Access Compliance Report

Public Rights-of-Way

(Curb Ramps)

Intersection ID: 27907	Main Street: BAY_HILL_CLUB_DR	Cross Street: COLONIAL_COUNTRY_LN	Location:	N
ADA ID: 452B6C96759E	Ramp Type: Perp	Initial Pass/Fail: Fail	Overall Compliance: No	Severity Score: 1.25
Codes/Mitigation Info/Possible Solution		Field Measurements/Component Compliance

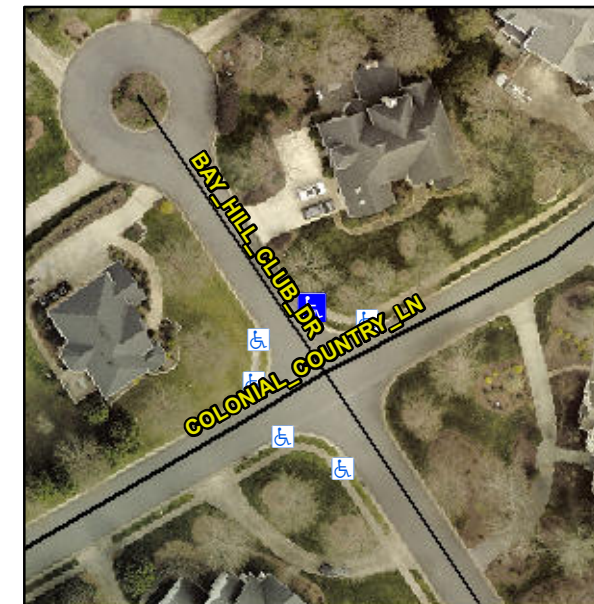
Compliance	Description	Data	Compliance	Description	Data
N/A	Ramp Length (in)	96.0	Yes	Ramp Slope (%)	5.4
Yes	Ramp Width (in)	49.0	No	Ramp XSlope (%)	2.6
N/A	Flare Type LT	N/A	N/A	Flare Type RT	N/A
N/A	Flare Slope LT (%)	N/A	N/A	Flare Slope RT (%)	N/A
N/A	Flare Traversable LT?	N/A	N/A	Flare Traversable RT?	N/A
N/A	Landing Length (in)	N/A	N/A	DWS Provided?	N/A
N/A	Landing Width (in)	N/A	N/A	DWS Contrast?	N/A
N/A	Landing Slope (%)	N/A	N/A	DWS Length (in)	N/A
N/A	Landing X Slope (%)	N/A	N/A	DWS Full Width?	N/A
N/A	Landing Curb? (Y/N)	N/A	N/A	DWS Offset (in)	N/A
N/A	Shared Landing?	N/A			
N/A	Gutter Ponding?	N/A	N/A	Gutter Slope (%)	N/A
N/A	Gutter Lip Ht (in)	N/A	N/A	Gutter X Slope (%)	N/A
N/A	Painted X Walk1?	No	N/A	Painted X Walk2?	N/A
	X Walk 1 Direction	To SW		X Walk 2 Direction	N/A
N/A	X Walk 1 Width (in)	N/A	N/A	X Walk 2 Width (in)	N/A
	X Walk 1 Slope (%)	1.0		X Walk 2 Slope (%)	N/A
	X Walk 1 X Slope (%)	0.5		X Walk 2 X Slope (%)	N/A

Remove & Replace Entire Ramp.

R304.5.3
